World Forum for Harmonization of Vehicle Regulations

1958 Agreement – Consideration of draft amendments to existing Regulation

Proposal for the 05 series of amendments to Regulation No. 48 (Installation of lighting and light-signalling devices)

Submitted by the Working Party on Lighting and Light-Signalling (GRE)*

Model A

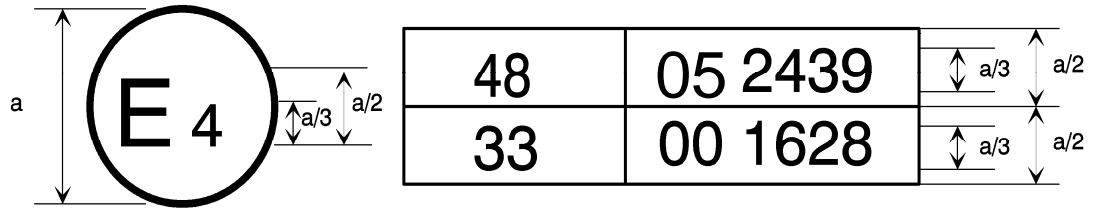
Annex 2, amend to read:

The above approval mark affixed to a vehicle shows that the vehicle type concerned has, with regard to the installation of lighting and light-signalling devices, been approved in the Netherlands (E4) pursuant to Regulation No. 48 as amended by the 05 series of amendments. The approval number indicates that the approval was granted in accordance with the requirements of Regulation No. 48 as amended by the 05 series of amendments.
